ADDENDUM #1

Project: E.E. Bass Cultural Arts Center
Phase II – Site and Building Improvements
Greenville, Mississippi

Professional: Beard + Riser Architects PLLC

Date Issued: March 8, 2016

C-2

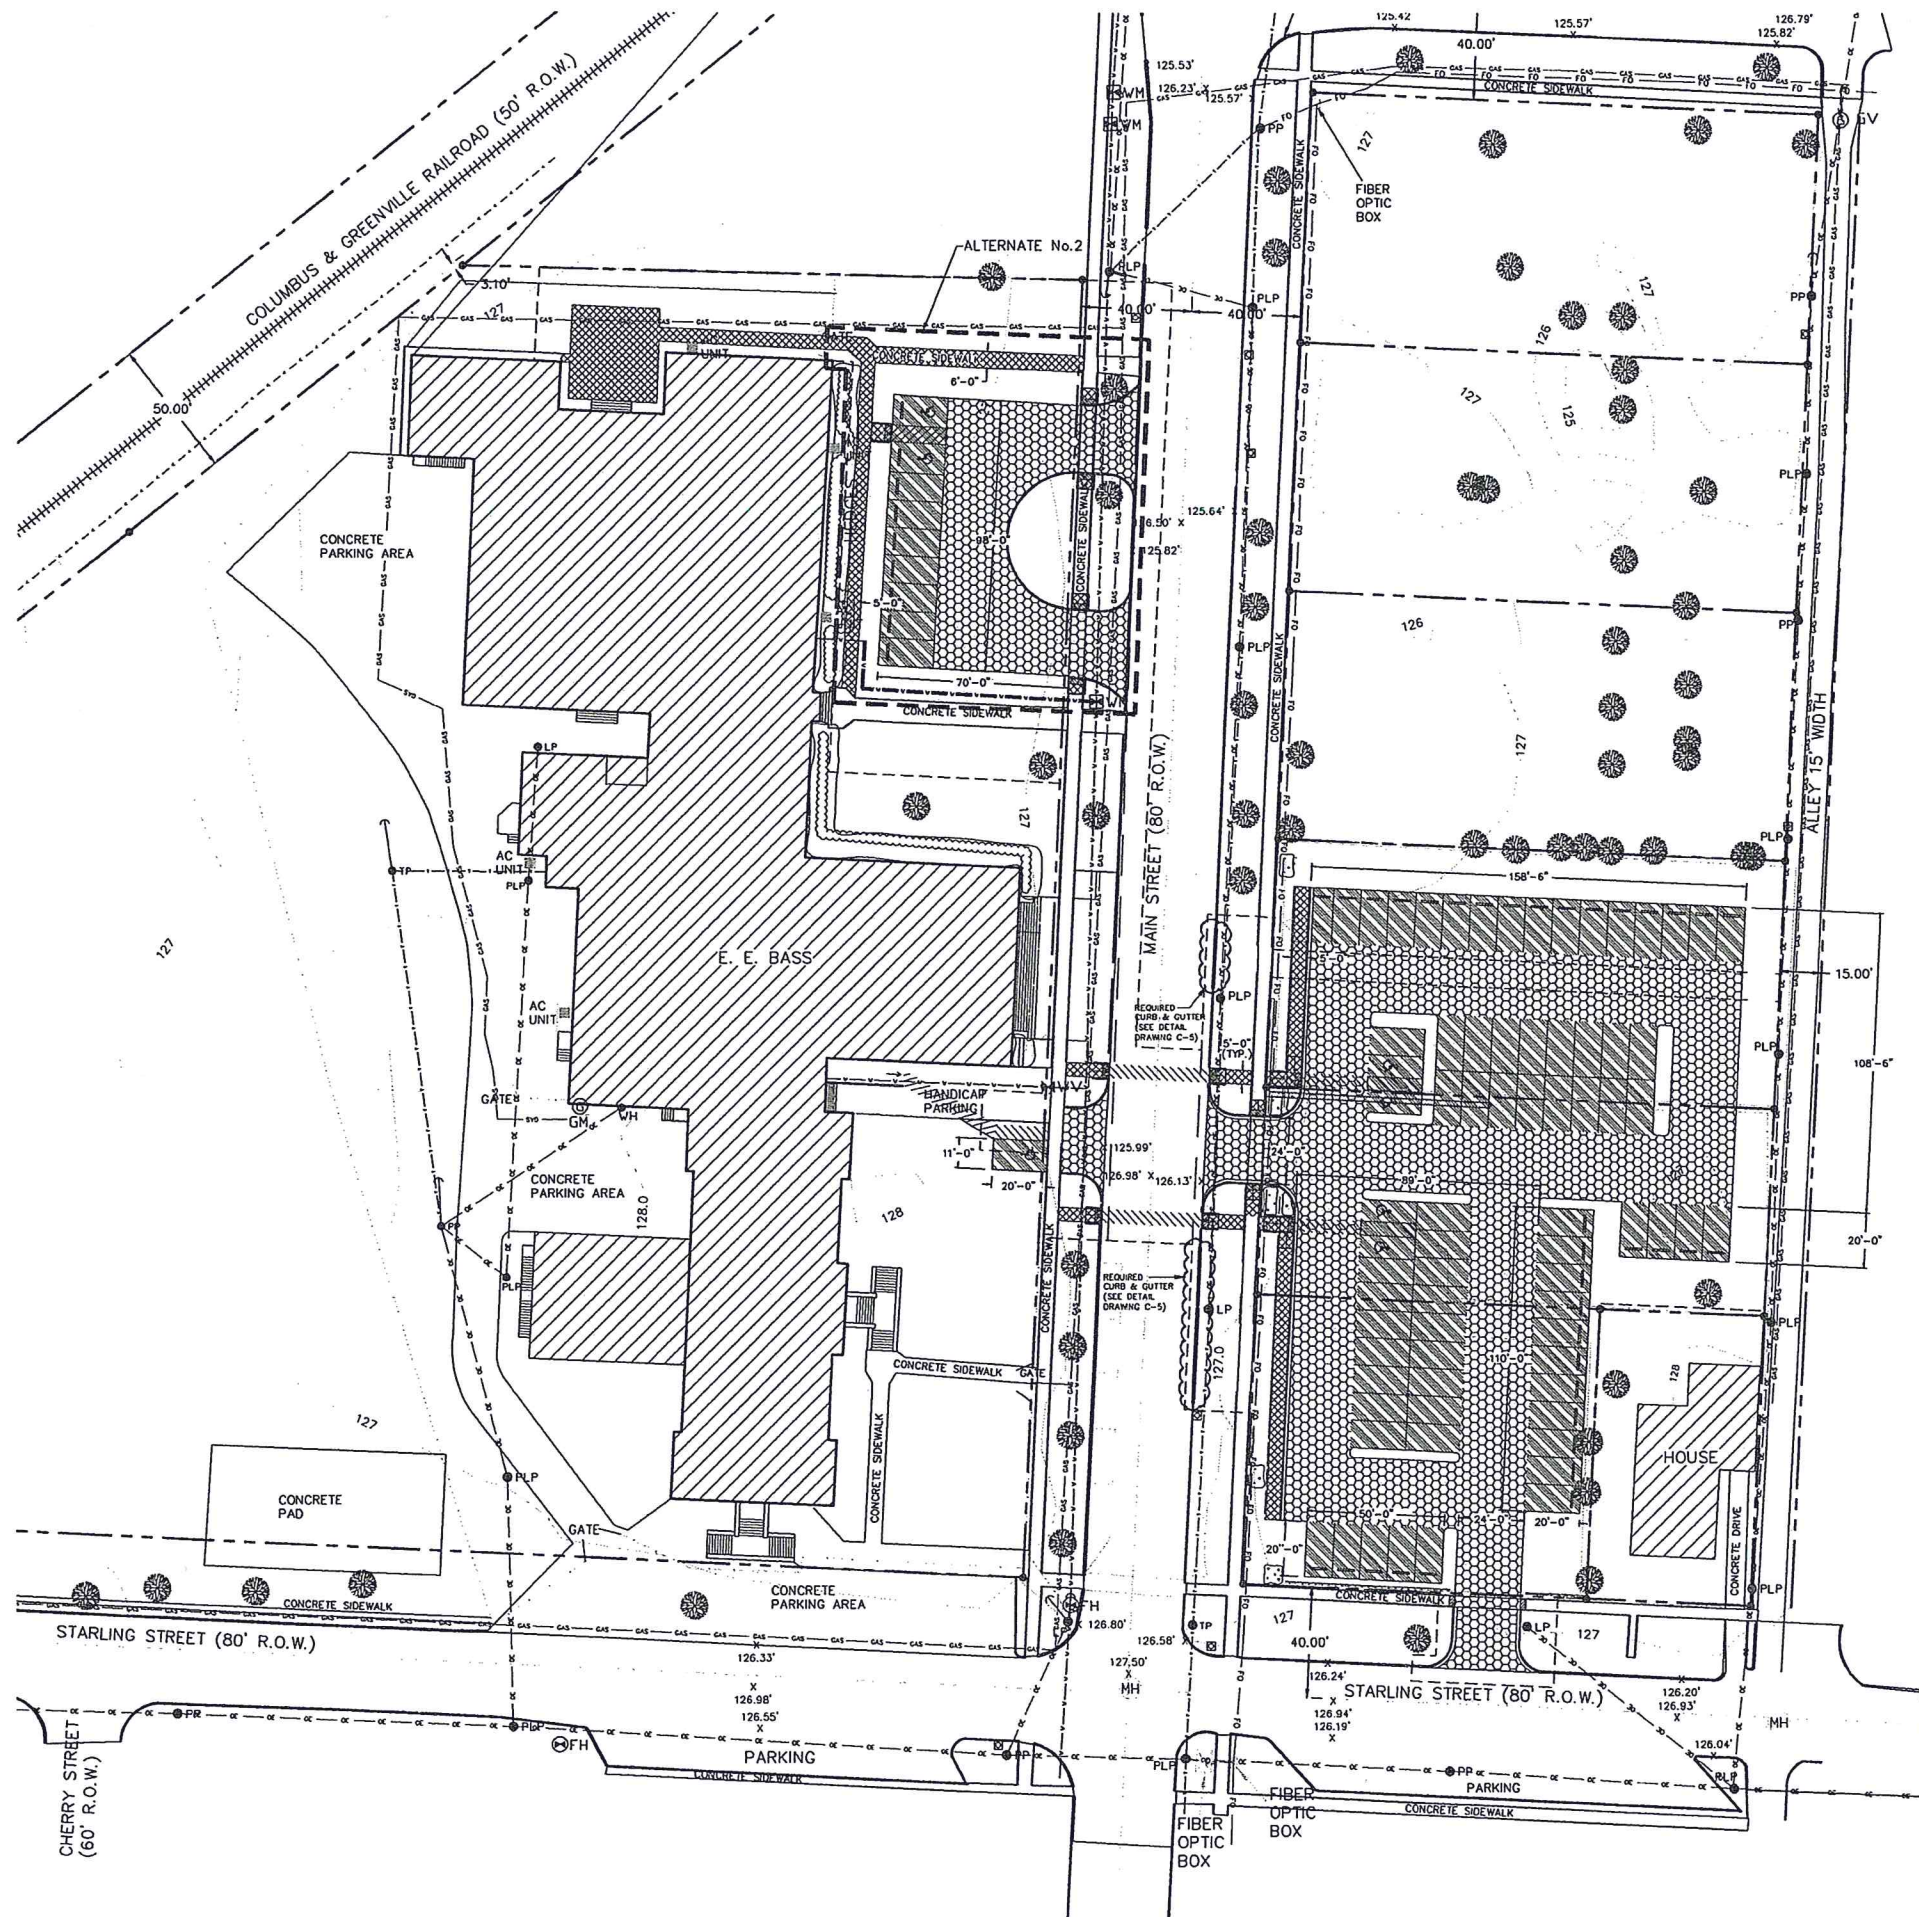
3. **Item 3:** Sheet C-2 Alternate No. Four: Indicates the East parking lot as a mix of heavy and light duty concrete pavement in lieu of asphalt paving.

- D. Alternate No. Four: Omit asphalt paving at east parking lot and provide concrete as indicated on revised drawing C-2 attached.

Alternate No. Four: Omit asphalt paving at East Parking Lot and provide concrete as indicated on revised drawing C-2 attached.
